# 233<sup>rd</sup> Meeting of the Machine Protection Panel - Join meeting with the Collimation Working group

## LHC topics

March 10<sup>th</sup>, 2023, via Zoom

## VELO interfaces important for risk assessment

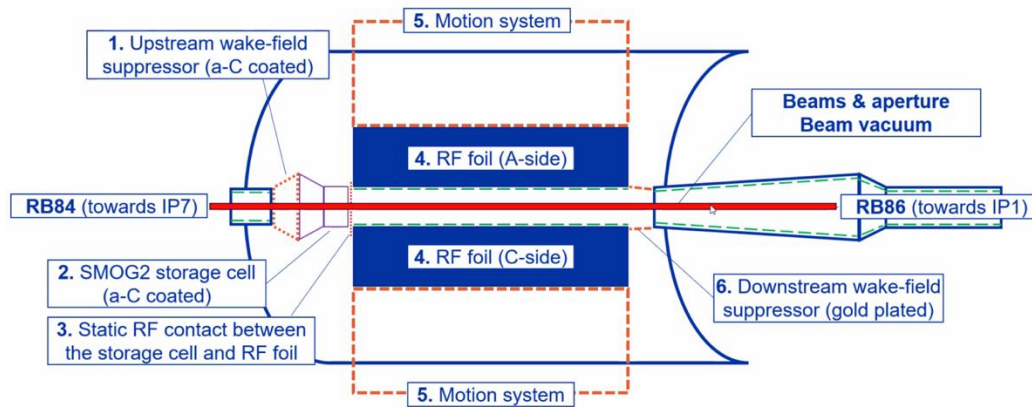
The impacts concern the possible deformation of the RF contacts upstream and downstream of the RF foil (see figure):

- (1) The upstream wake-field suppressor is not expected to have been affected by the incident.
- (3) The foil contact part has no loose part and is not expected to have been affected.
- (6) The downstream wake-field suppressor offers the possibility to be visually inspected through the downstream viewport. It appears that it has not been affected.

The deformed RF foil shape (as simulated) does not present an issue for the machine impedance. The probability to have a loss of a significant amount of RF contacts due to the incident is low.
